PLATTING BOARD AGENDA

PLATTING BOARD MEETING

November 17, 2022

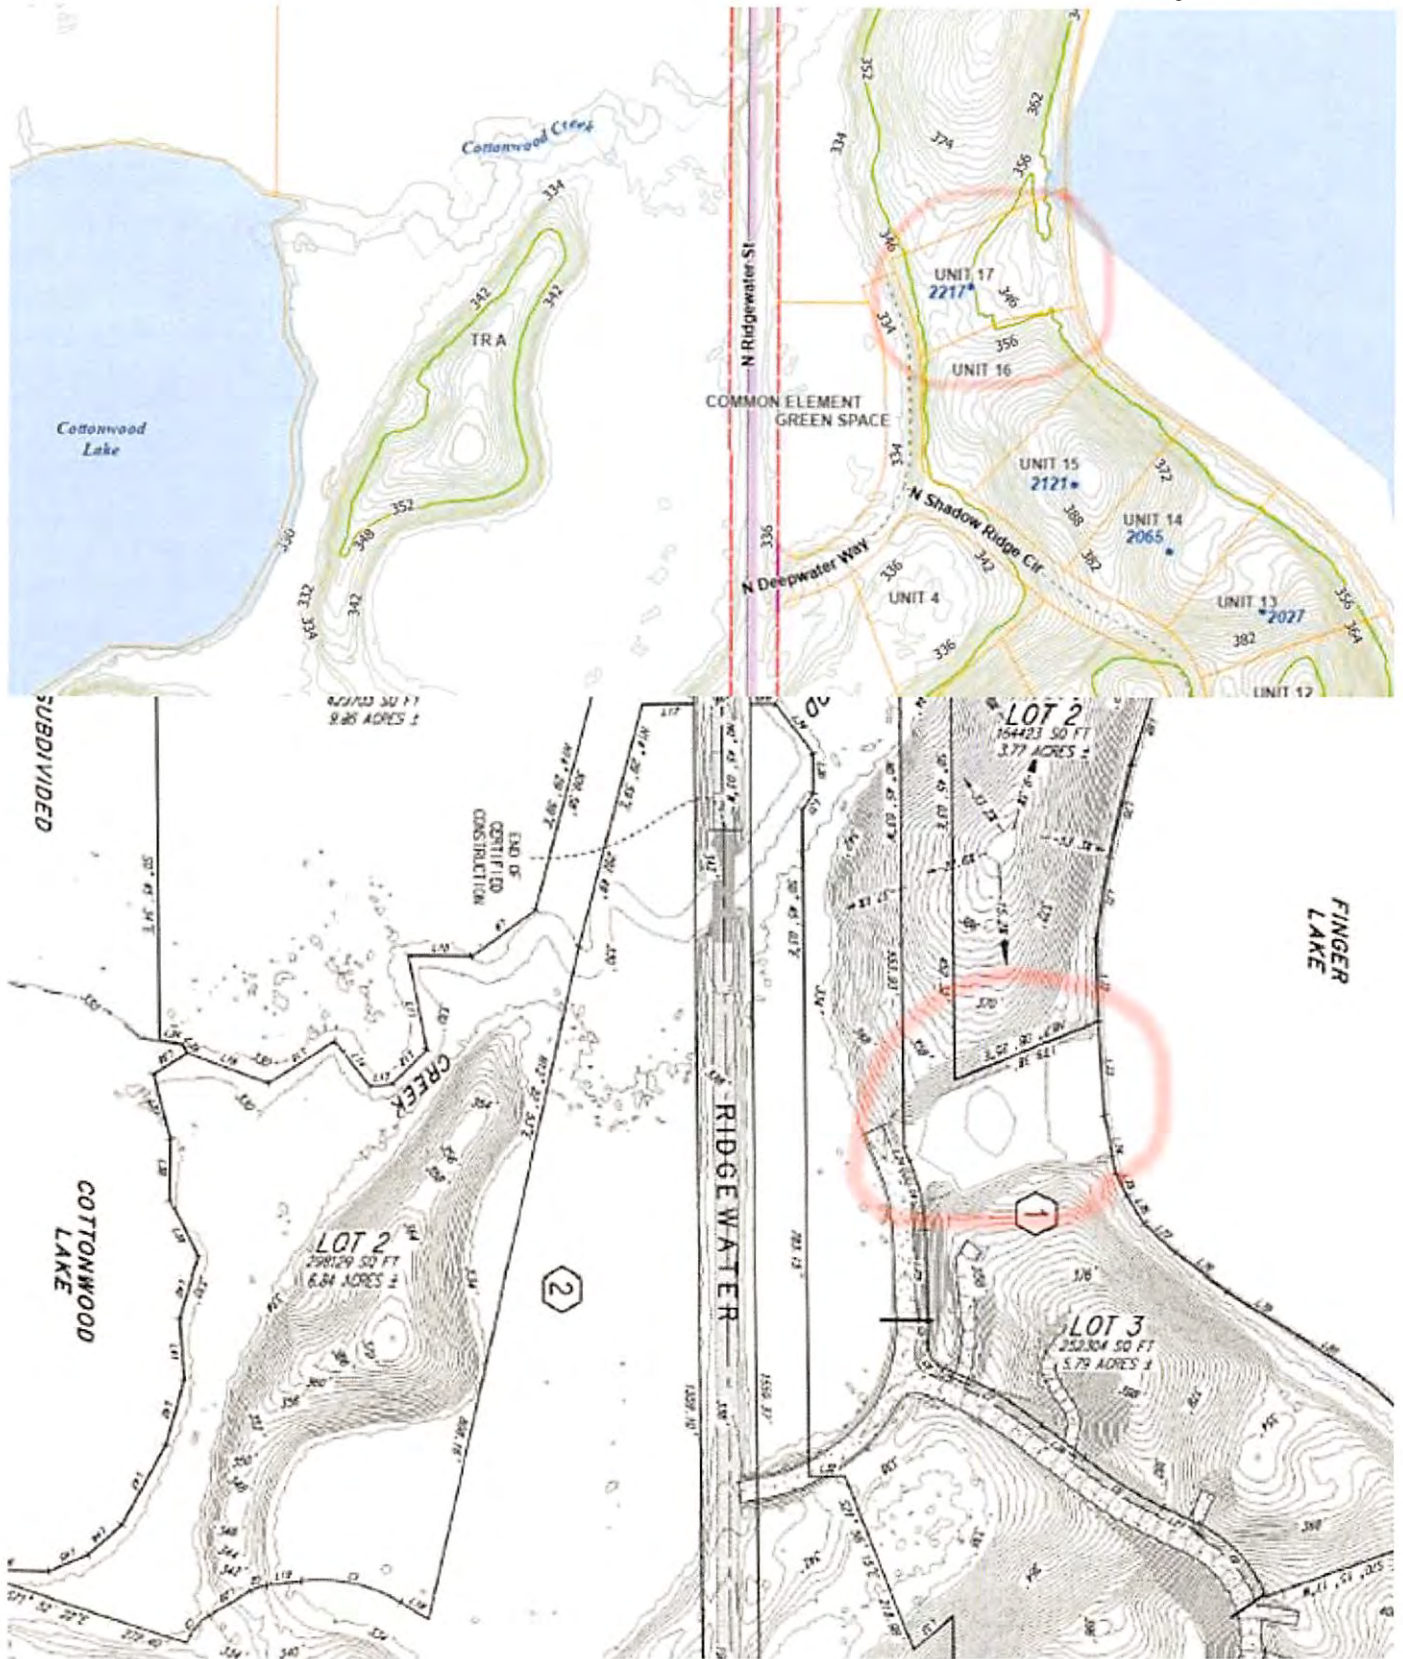
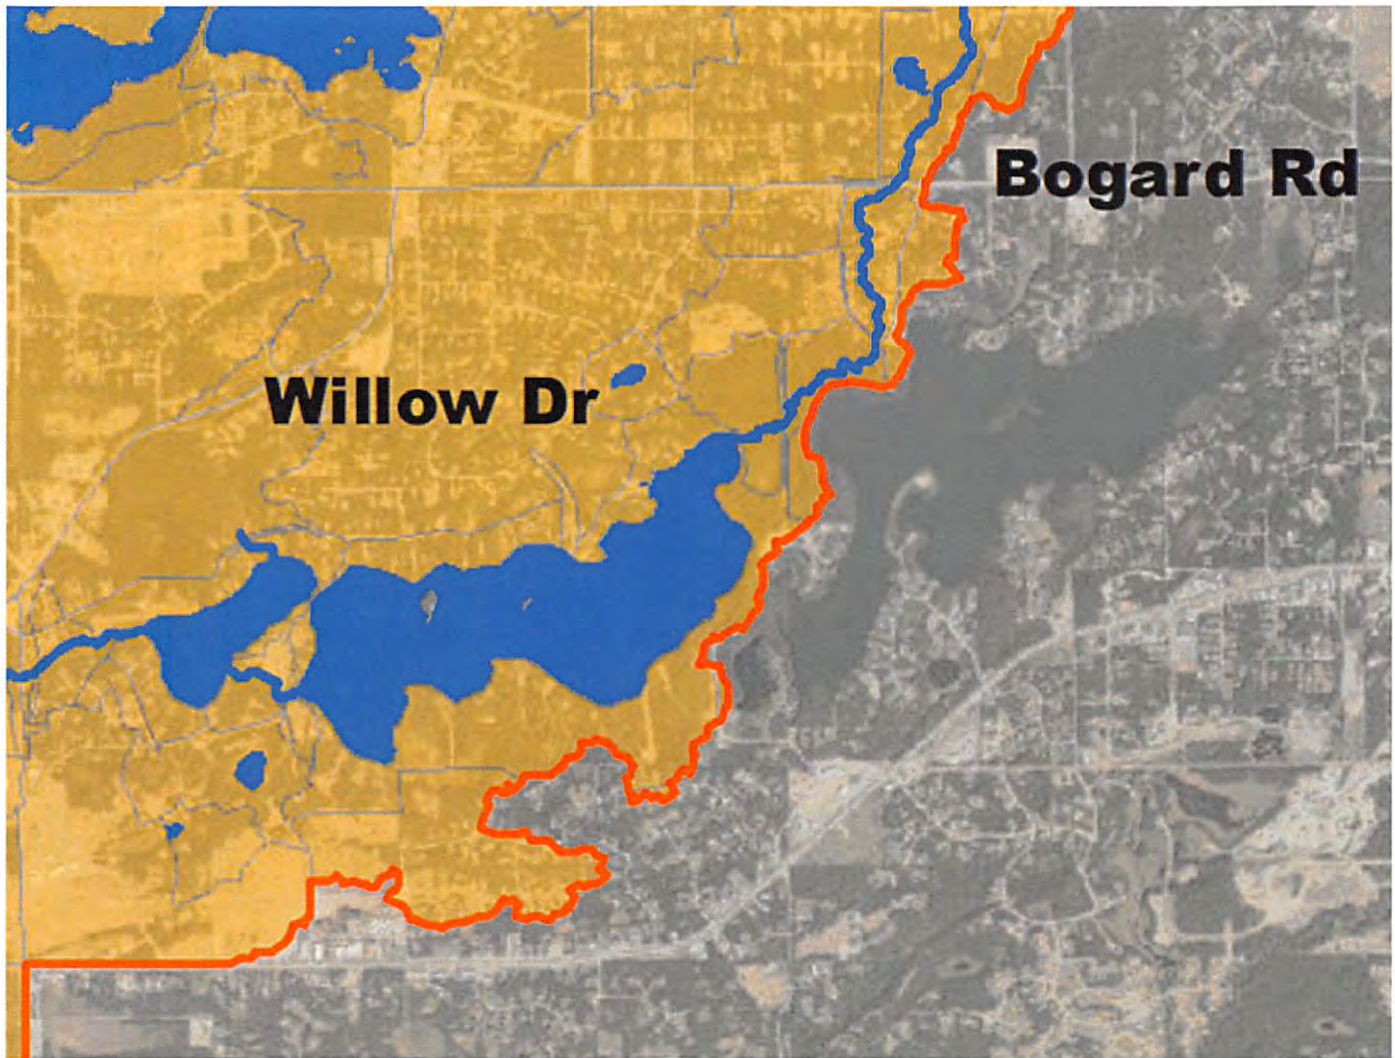
Upon reviewing the revised submittals (attached), I have the following comments in addition to my previous rounds of comments:

- The report references lot numbers and layout of a previous version of the subdivision design. The soils report must be updated for the current subdivision design.

- The testholes referenced in the aforementioned soils report aren't actually located on any of the lots less than 400,000 sf – the topography in the area is quite varied and I question the extrapolation of testhole data to that extent – the soils report should be updated to include testholes within the areas being certified as useable area.

- Proposed regrading of upland areas should be shown on a topographic map to show that the needed useable area is achievable. A complete drainage study must be conducted and drainage report submitted for review and approval by DPW prior to any regrading.

- L1B2 appears to be entirely wetland. According to the soils report, a fill pad will be required to create useable septic area as Testhole 2 indicates at least 11 feet of peat and groundwater seeps at 3 feet below ground. Wetlands are highly valuable components of the environment and their disturbance should be minimized to the extent possible. There could be severe implications from placing this much fill on saturated peat, the effects of which could take years to be seen. L1B2 should either be absorbed into an adjacent lot with sufficient uplands for useable area or should be designated as green space or similar.

- Revised Site and Topo (received by Platting on July 1, 2022) – MSB 2019 topo shows the subject parcel contains a ridge along the west shore of Finger Lake with a saddle elevation of 354' in the area of Unit 17 of the Lakebridge Condominium plat. The submitted topographic maps shows material was removed from the ridge at this location lowering the saddle elevation to approximately 342' which is at or near the same elevation of Finger Lake. I'm concerned this significantly changes the hydrology of the Cottonwood Creek and Wasilla Creek watersheds as they were not previously connected, and the ridge should be replaced to its pre-development elevation.

A PLAT OF DANDY BLUFFS 2022
A SUBDIVISION OF LOT 3
DANDY BLUFFS, PLAT 82018-93
ALL LOCATED WITHIN THE
N/2 SECTION 27, T. 17 N., R. 1 W.
SEWARD MERIDIAN, ALASKA
PALMER RECORDING DISTRICT
THIRD JUDICIAL DISTRICT
STATE OF ALASKA
CONTAINING 40.18 ACRES, MORE OR LESS

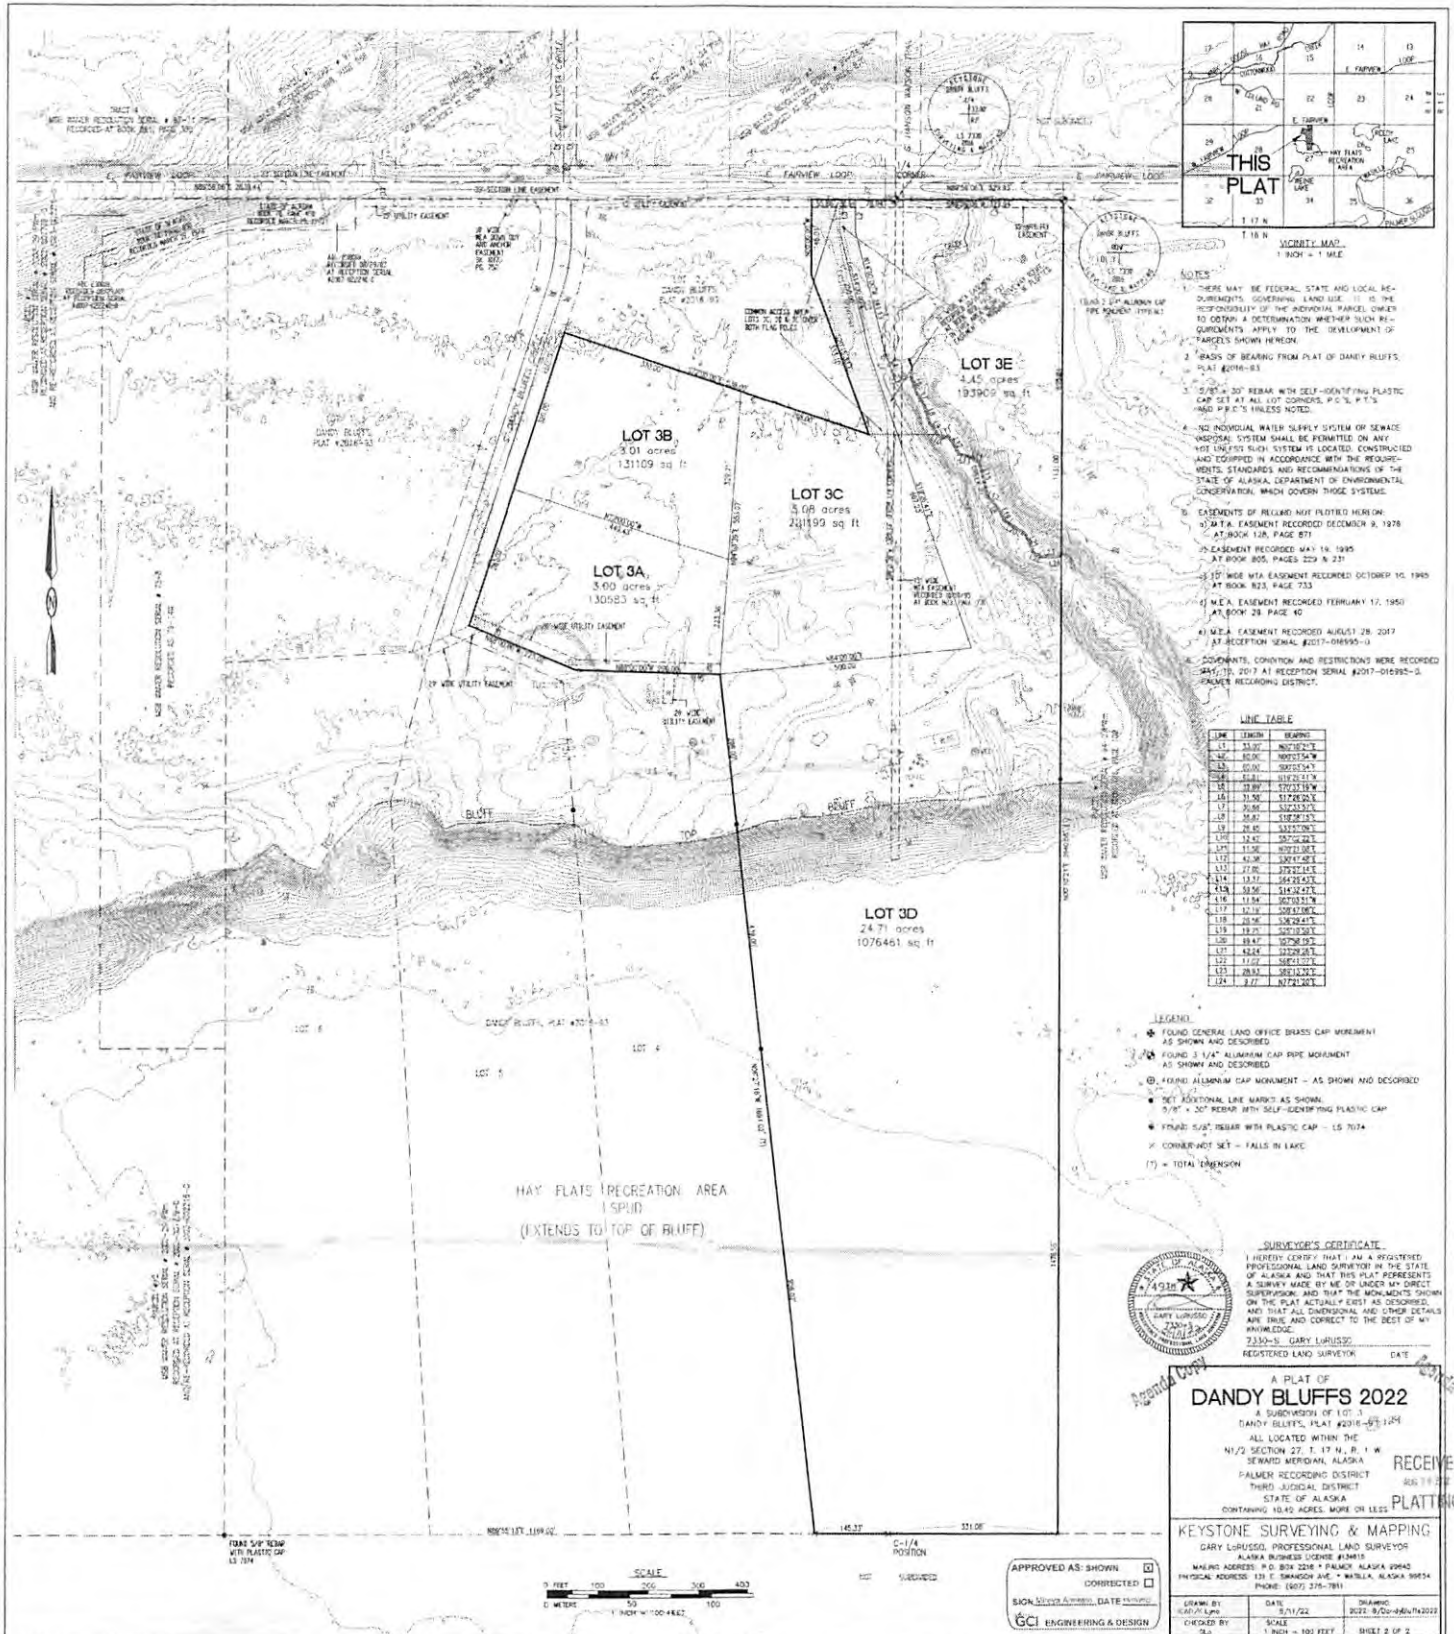
1. Add a note which says, "There is a ten foot (10 FT) wide natural gas easement centered on the existing service line." And draw in the approximate location of the service line on the map and add, "Approximate location of natural gas service line and centerline of ten foot (10 FT) wide natural gas easement".
2. Owner signs an ENSTAR Natural Gas Easement document for a ten foot (10 FT) wide natural gas easement, centered on the service line at this location.
